CITY OF WEST DES MOINES
PLAN AND ZONING COMMISSION COMMUNICATION

Item: JM Commercial Storage, 935 S. 50th Street – Matthew Gustafson - Approval of Site Plan to construct a 90,000 sq. ft. indoor storage building (SP-003787-2018) **(Deferred from May 7, 2018)**

Requested Action: Recommend Approval of Site Plan

C401

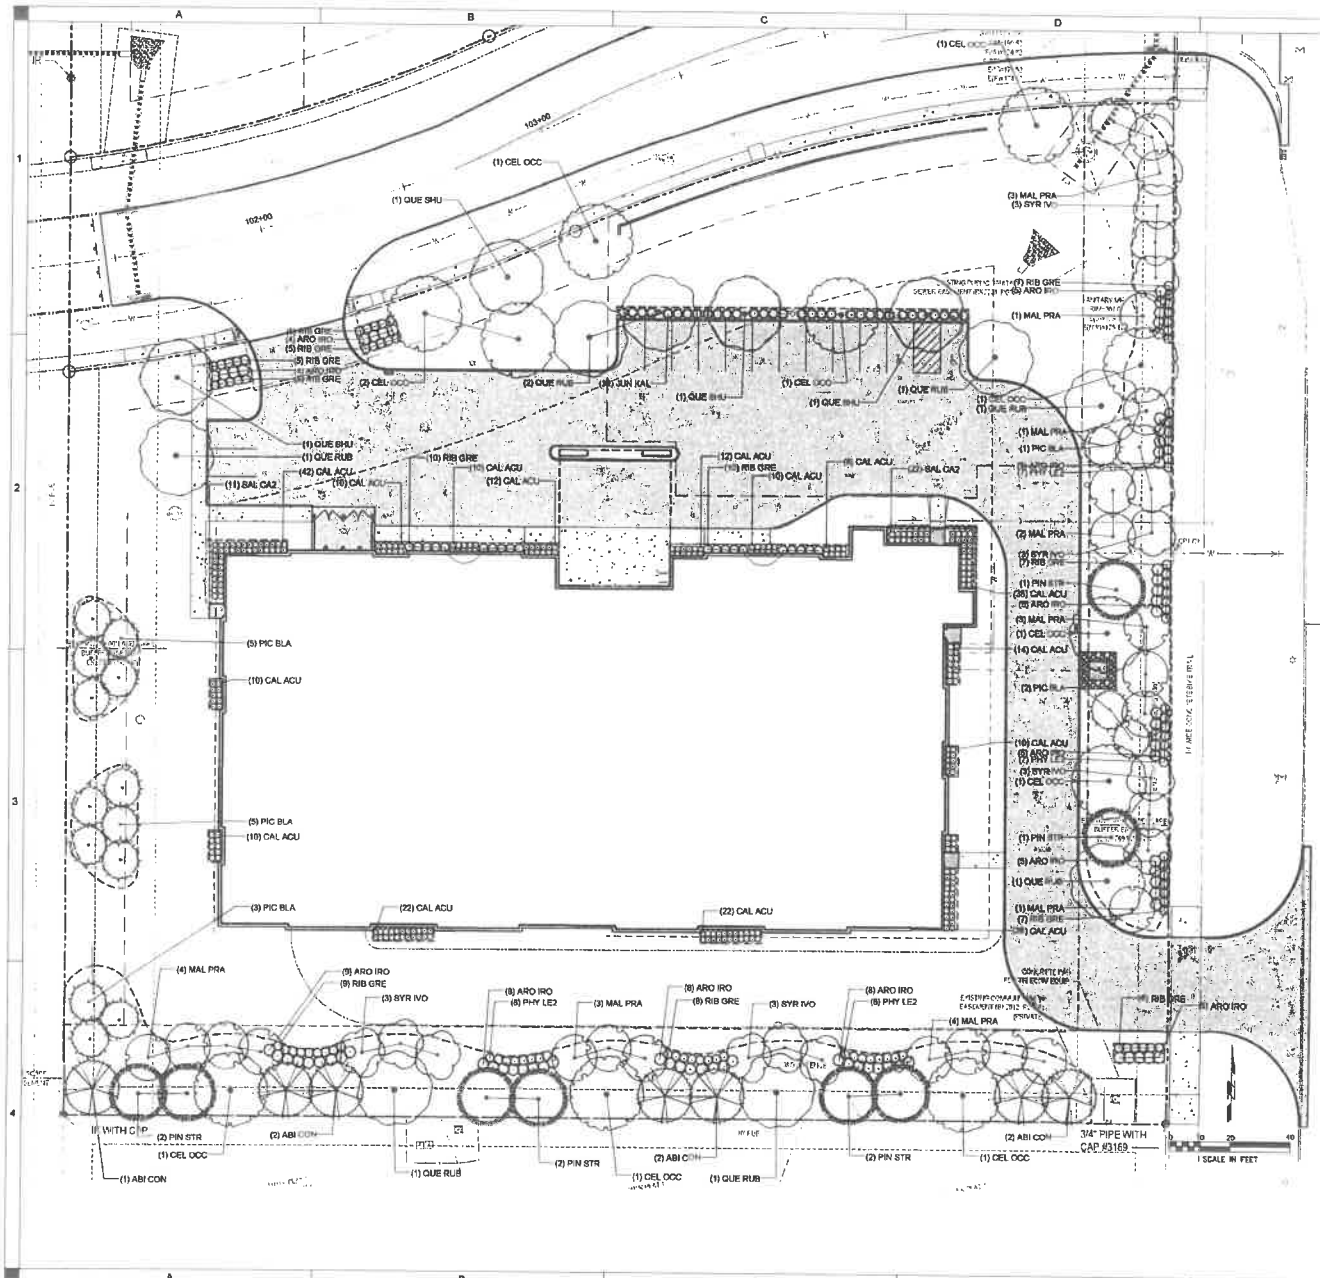
- *Citizen Comments*: through citizen comments received the site plan includes two atypical elements. The first is a fence and landscaping for the buffer on along the south of the property. Typically, a landscape buffer is required and fences are not usually used in addition to the landscape buffer. The second is the berm in the buffer along 50th Street is one foot higher than that normally required. These two items are included in the site plan by the applicant in direct response to citizen comments.

EXTERIOR ELEVATIONS

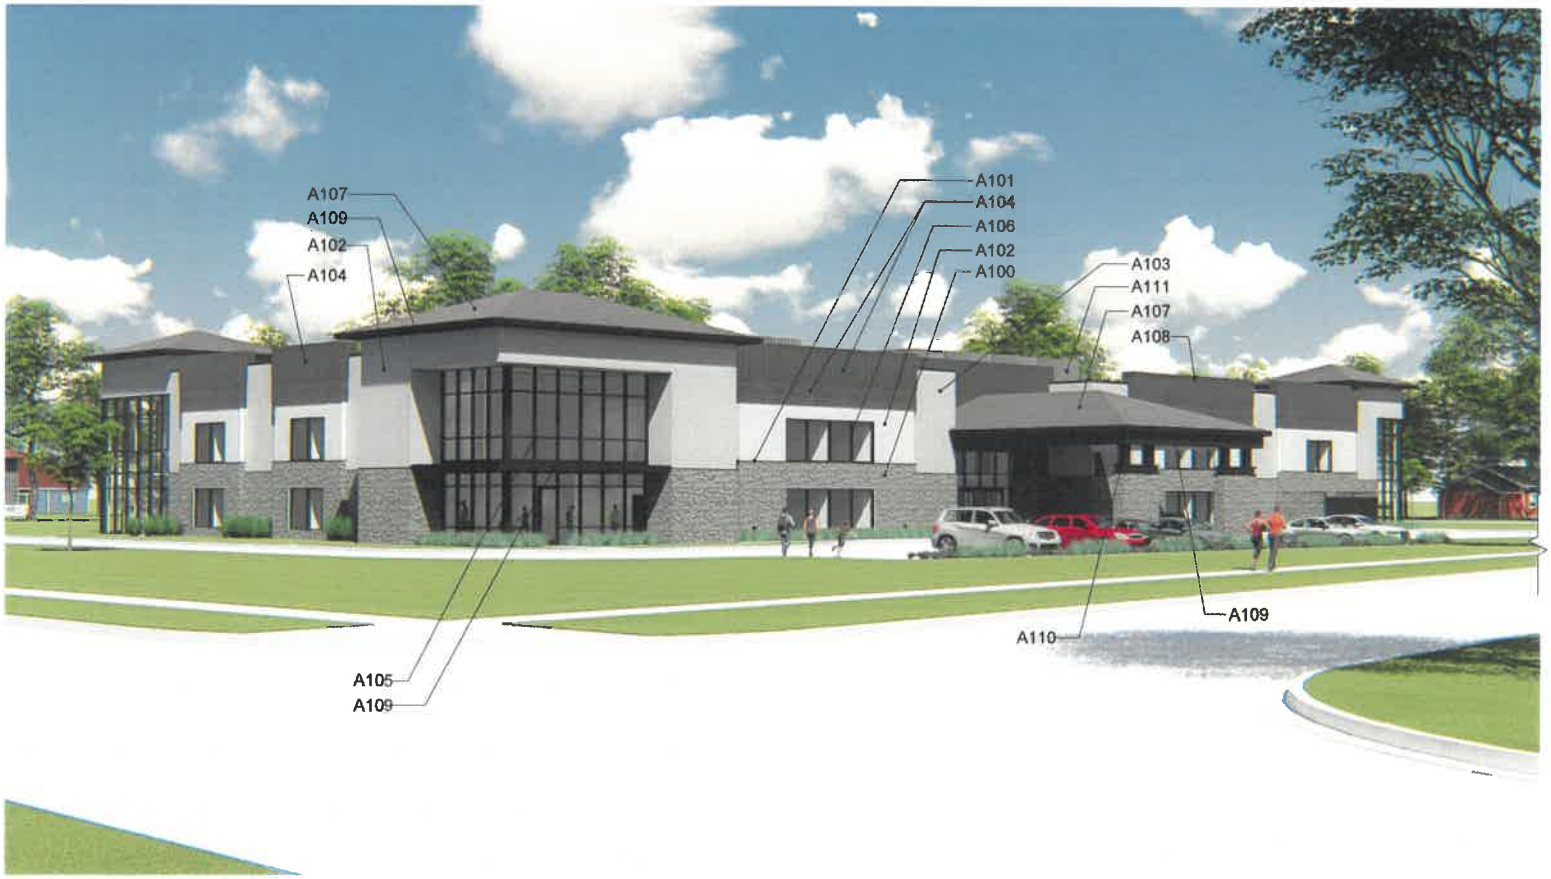
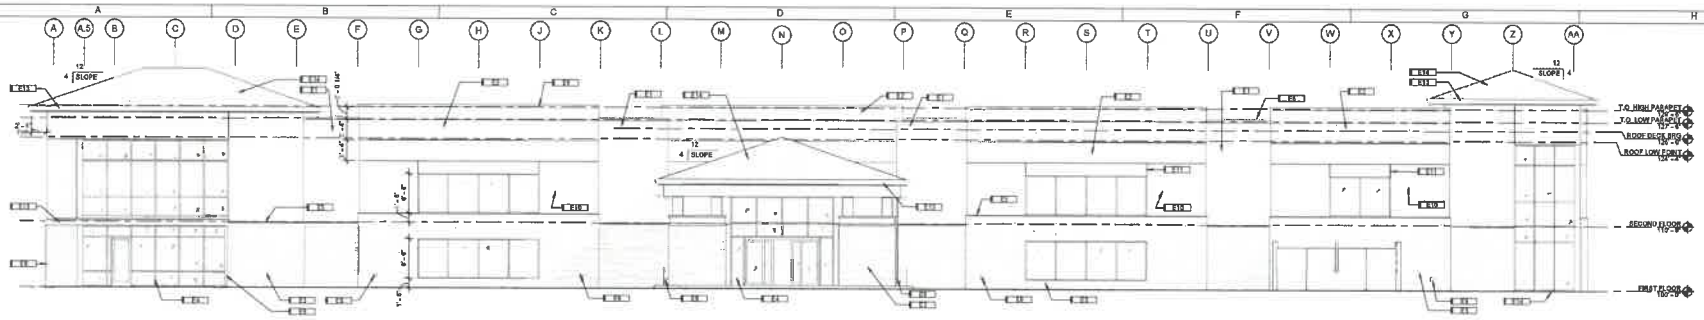
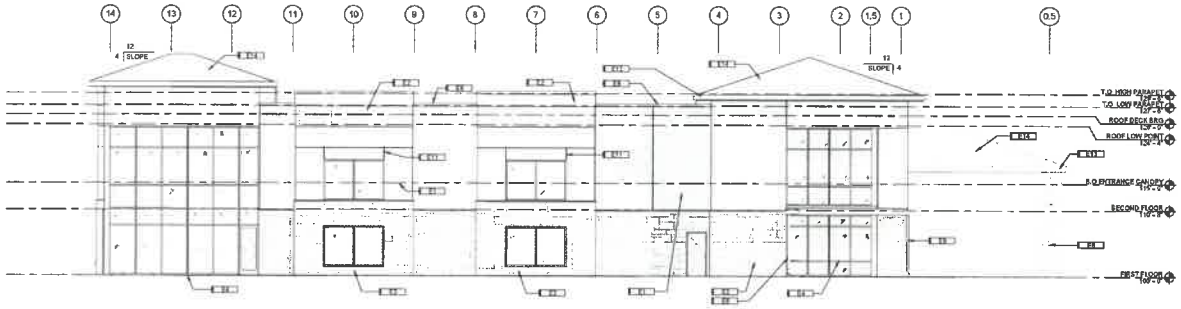
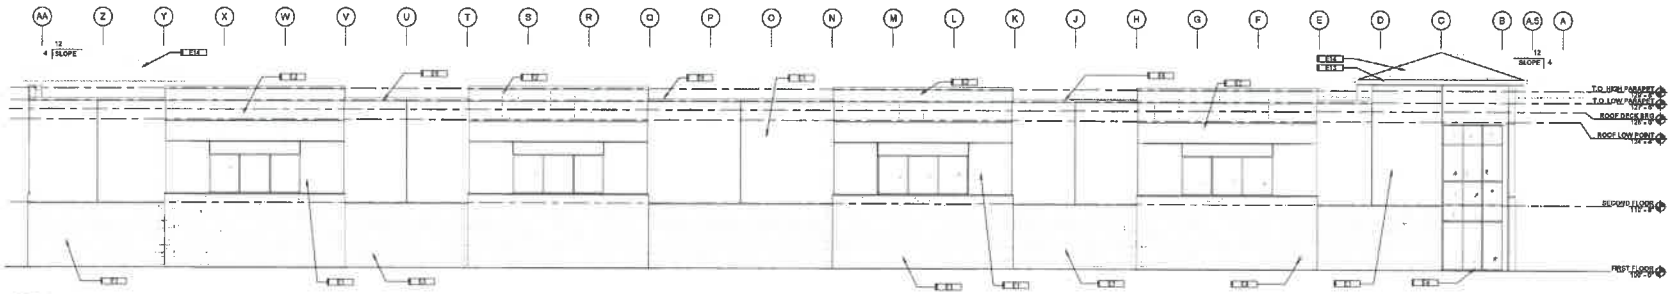
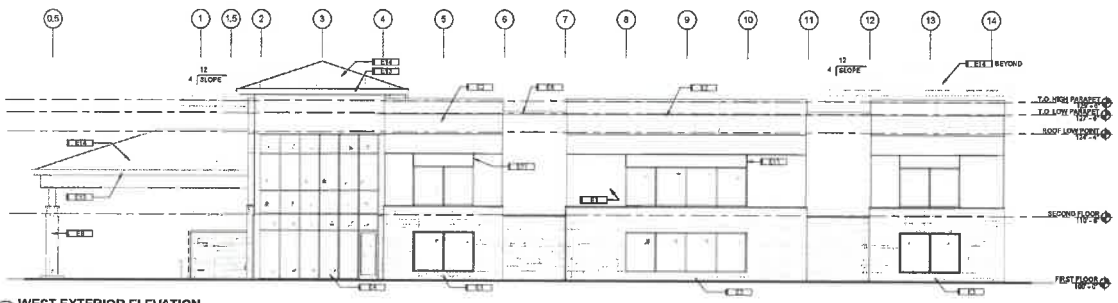
1. If planned roof top mechanical equipment is installed and exceeds the planned parapet height, the applicant will be responsible for providing additional screening of the mechanical equipment with either an architectural solution or other method acceptable to the City. Likewise, any unanticipated ground mounted or building mounted mechanical, meters, utilities will need to be appropriately screened.
